Airworthiness Directive Schedule

Airbus Helicopters AS 355 Series

26 March 2020

Figure: Airbus Helicopters recommended CG position of forward two-place seat.

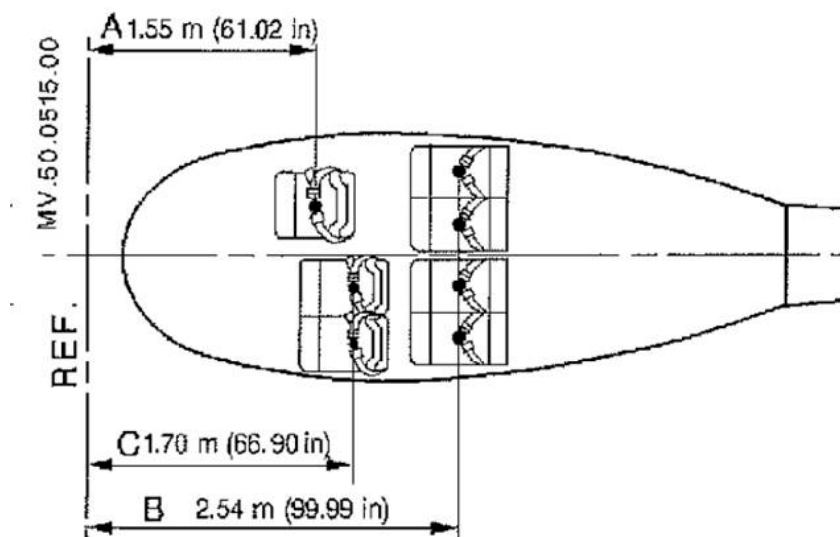
Annotate the CAA2173 to include the value of the longitudinal moment arm of the forward two-place seat used.
